**Addendum #1**  
**2020 Roadway Improvement Project**  
**“Cambridge Drive Neighborhood”**  
**Bid No. 20-15**  
**Town of East Hartford**

**February 28, 2020**

The following summarizes the revisions to the Bid Documents included in Addendum #1 for the 2020 Roadway Improvement Project (Bid No. 20-15).

PROJECT NO.:  
**42413.00**  
DRAWING NO.:  
**DCP-02**  
SHEET NO.:  
**115 OF 294**

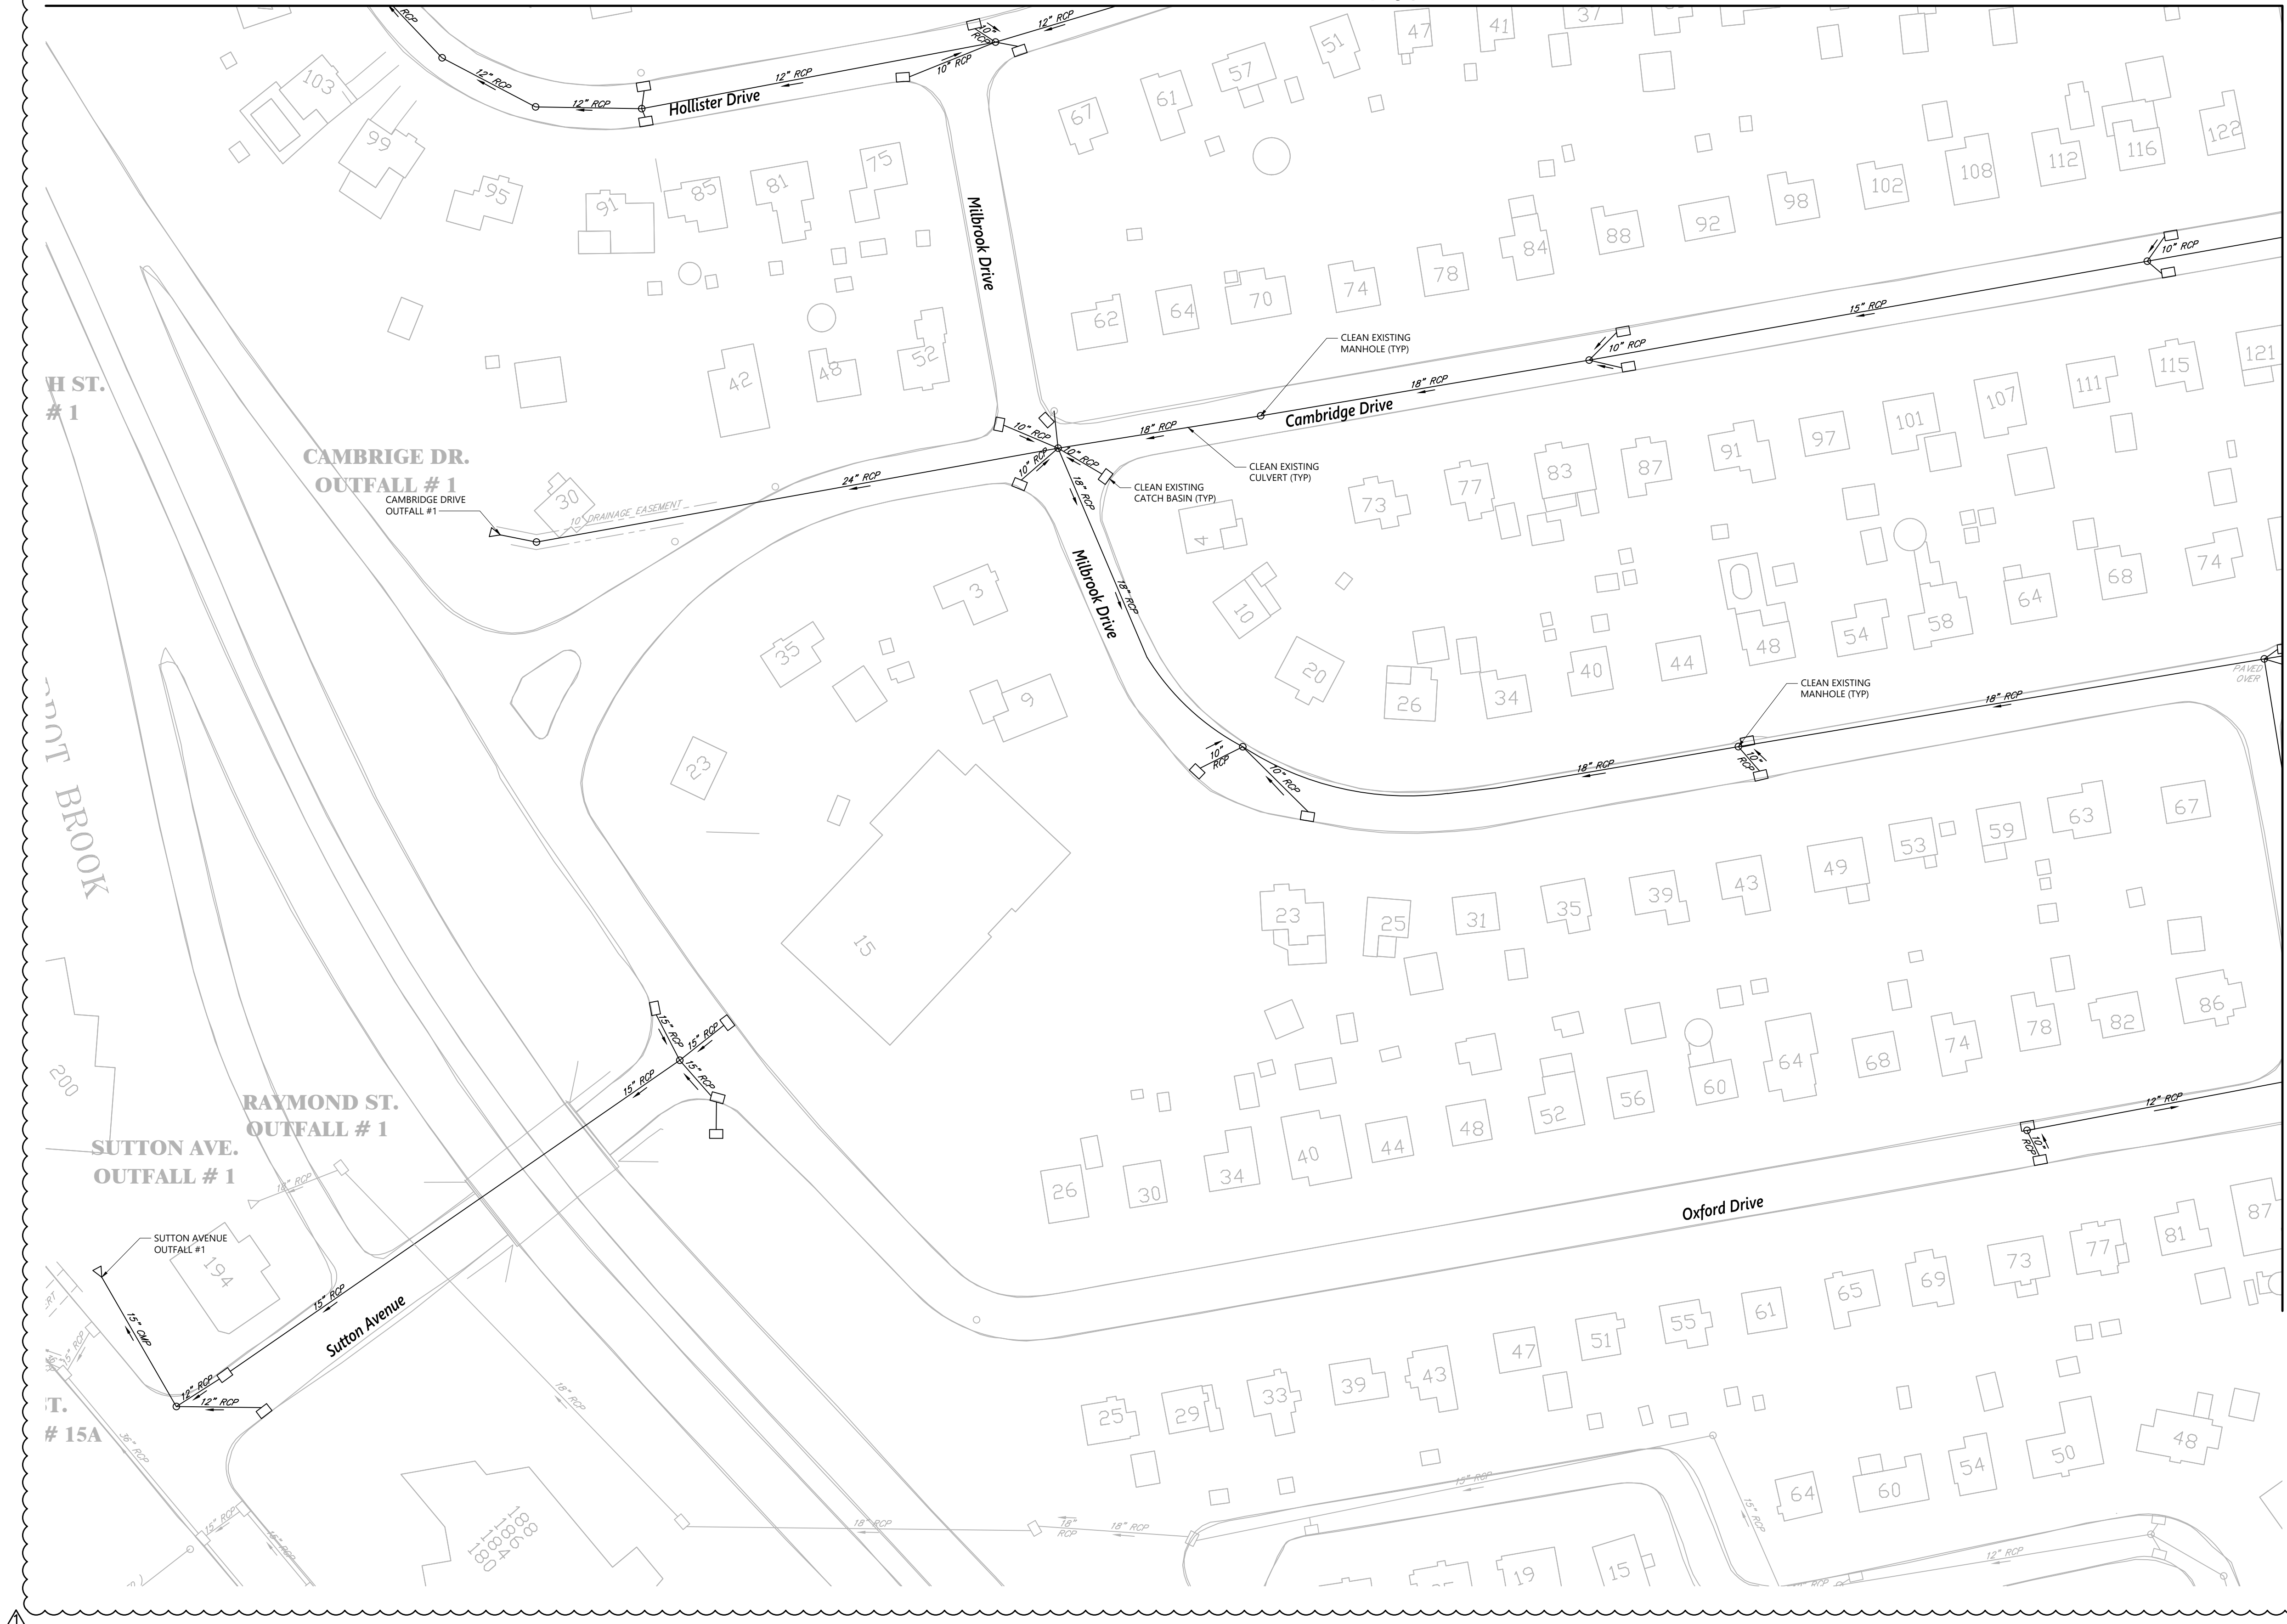
- Replace plan sheet 115 of 294 to reflect revised catch basin cleaning.
- Replace plan sheet 116 of 294 to reflect revised catch basin cleaning.
- Replace plan sheet 117 of 294 to reflect revised catch basin cleaning.
- Replace plan sheet 118 of 294 to reflect revised catch basin cleaning.
- Replace plan sheet 119 of 294 to reflect revised catch basin cleaning.

REV.	DATE	DESCRIPTION	SHEET NO.
1	02/27/20	REVISED CATCH BASIN CLEANING	115

PROJECT NO.:  
**42413.00**  
DRAWING NO.:  
**DCP-03**  
SHEET NO.:  
**116 OF 294**

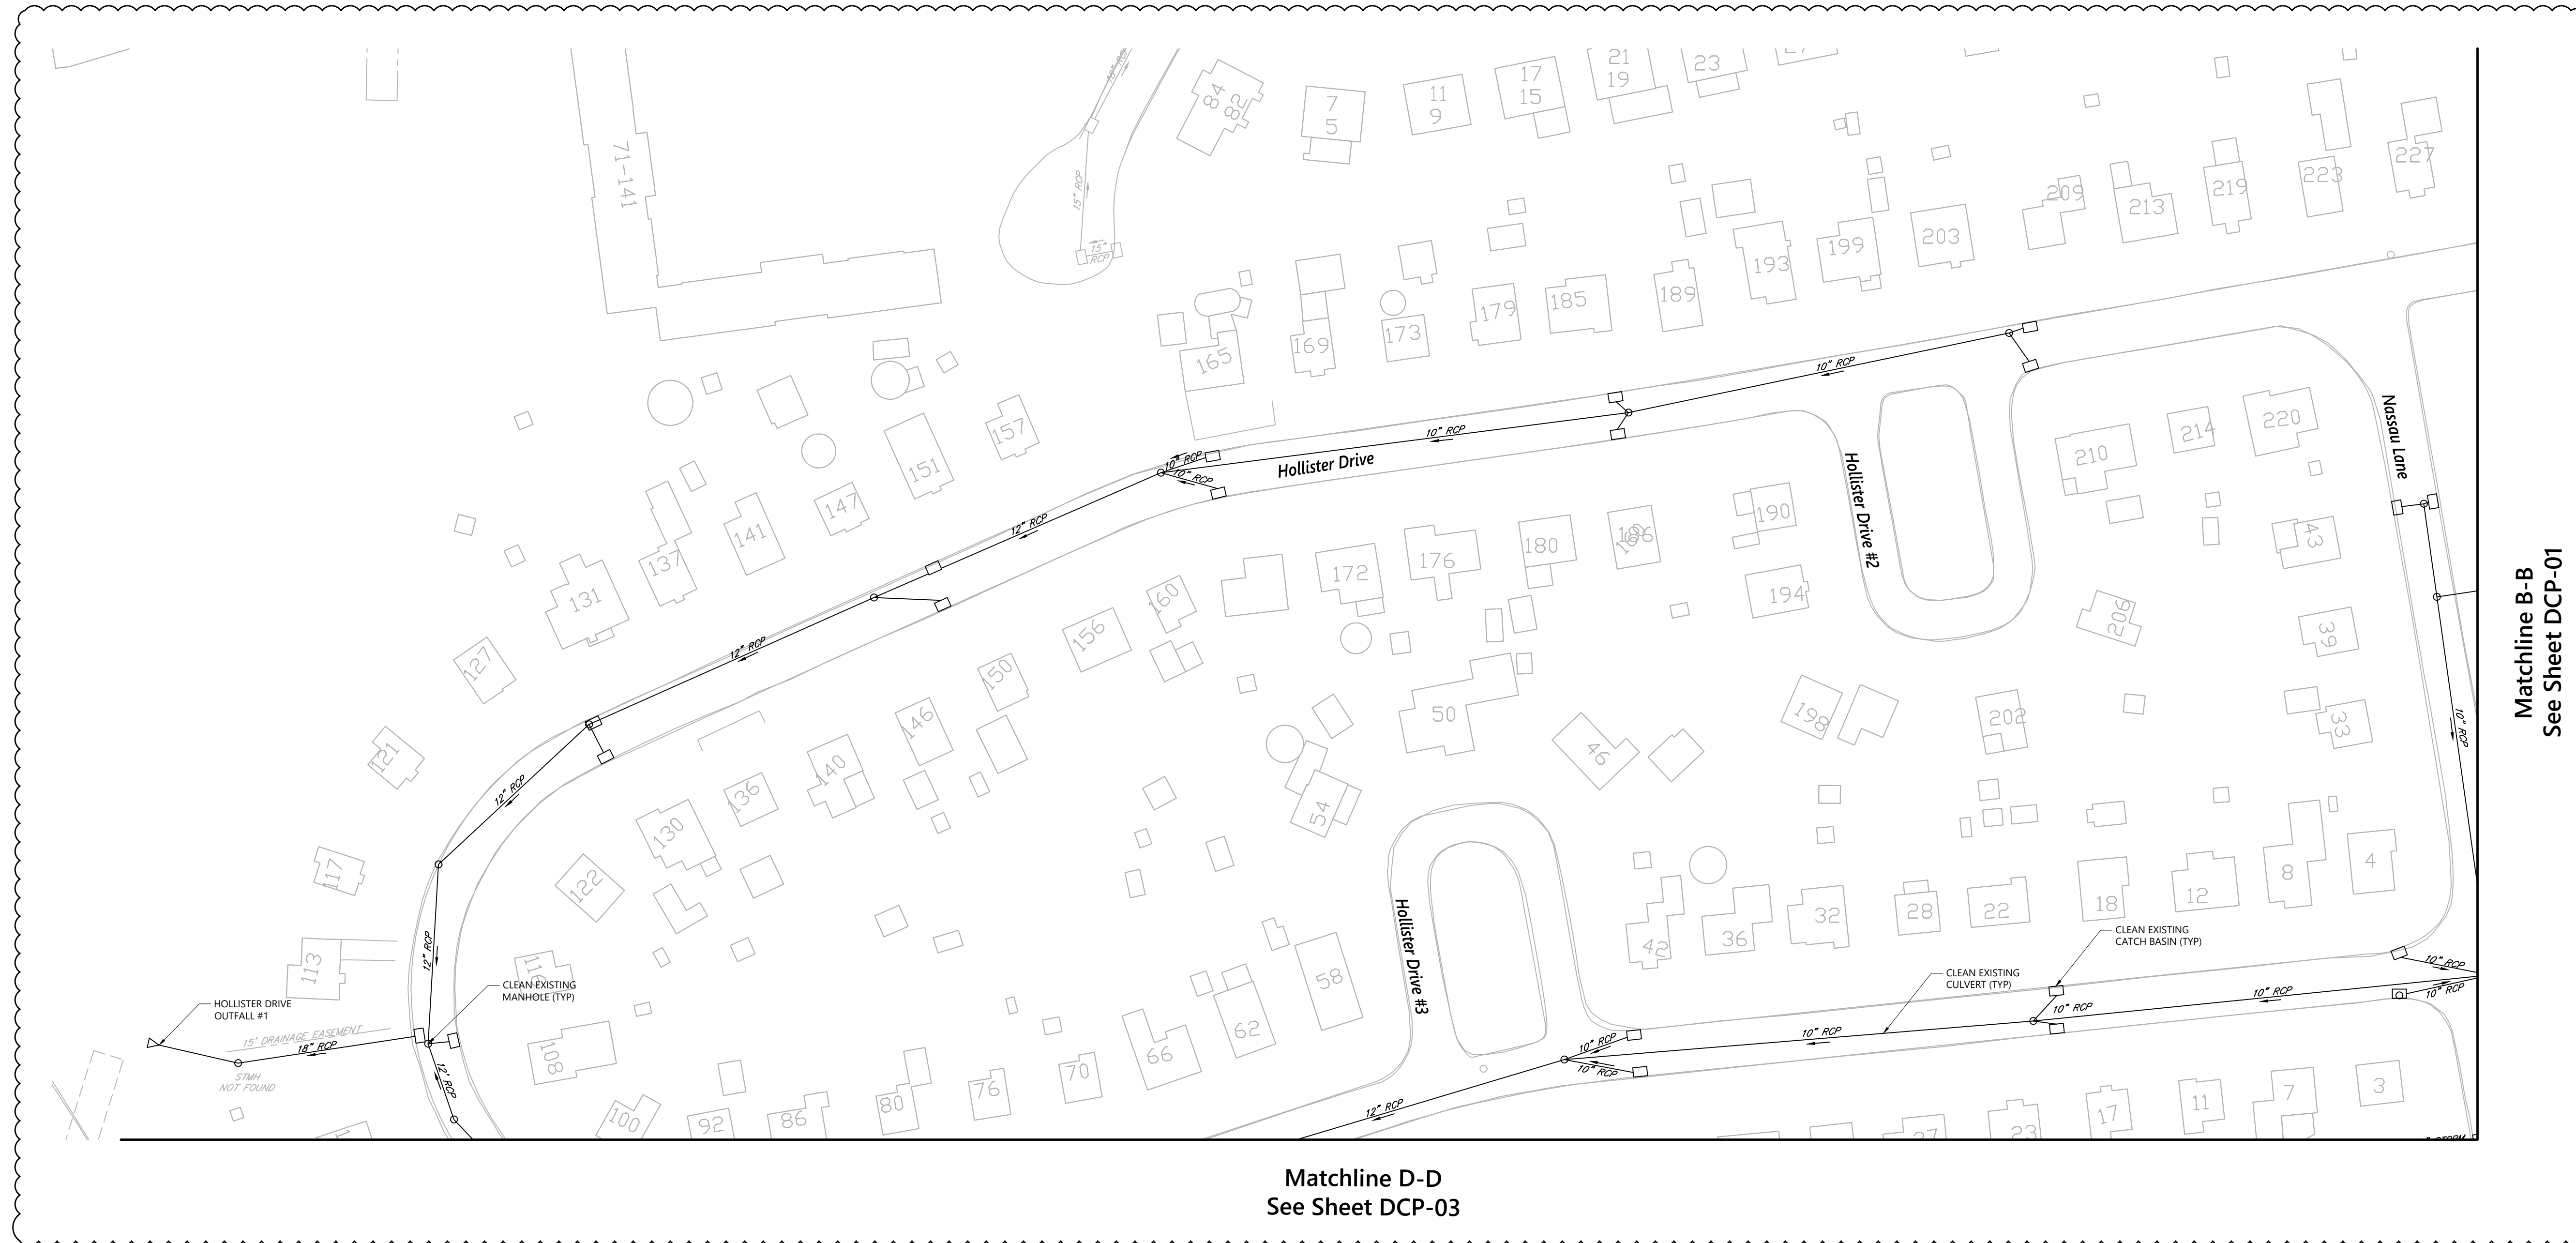
REV.	DATE	DESCRIPTION	REVISIONS	SHEET. NO.
1	02/27/20	REVISED CATCH BASIN CLEANING		116

PROJECT NO.:  
**42413.00**  
DRAWING NO.:  
**DCP-05**  
SHEET NO.:  
**118 OF 294**

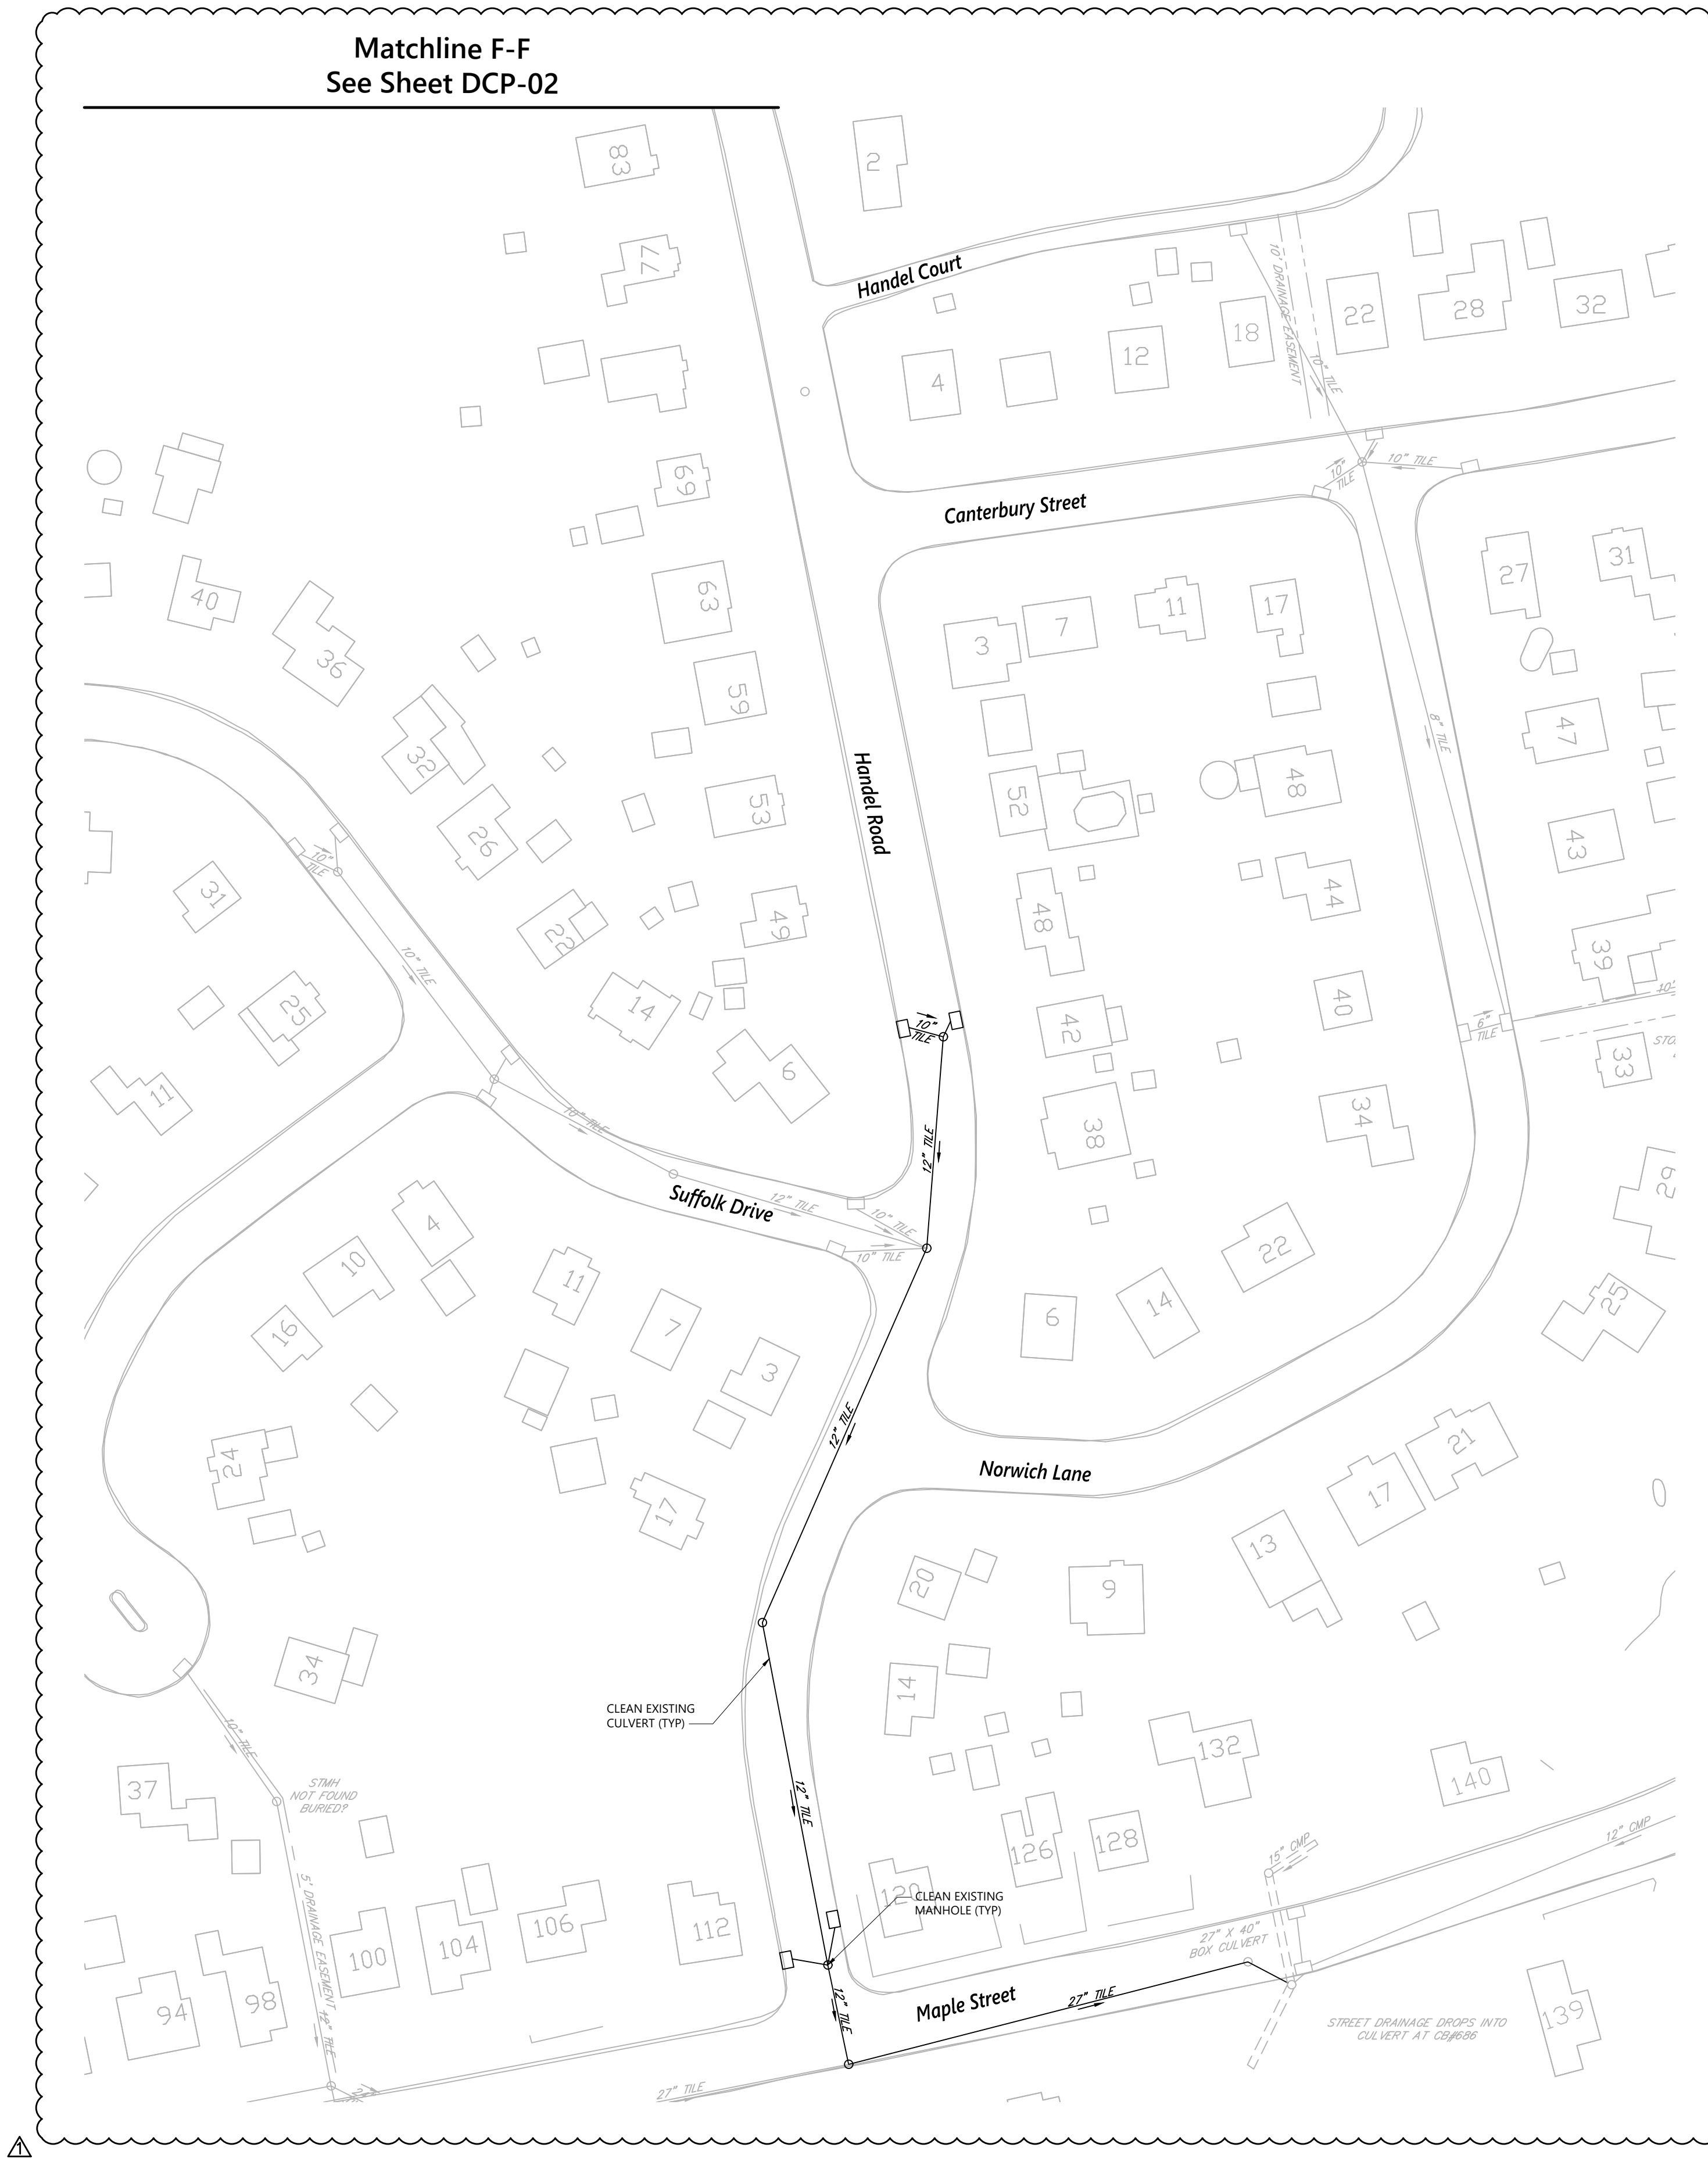
REV.	DATE	DESCRIPTION	SHEET. NO.
Δ	02/27/20	REVISED CATCH BASIN CLEANING	118
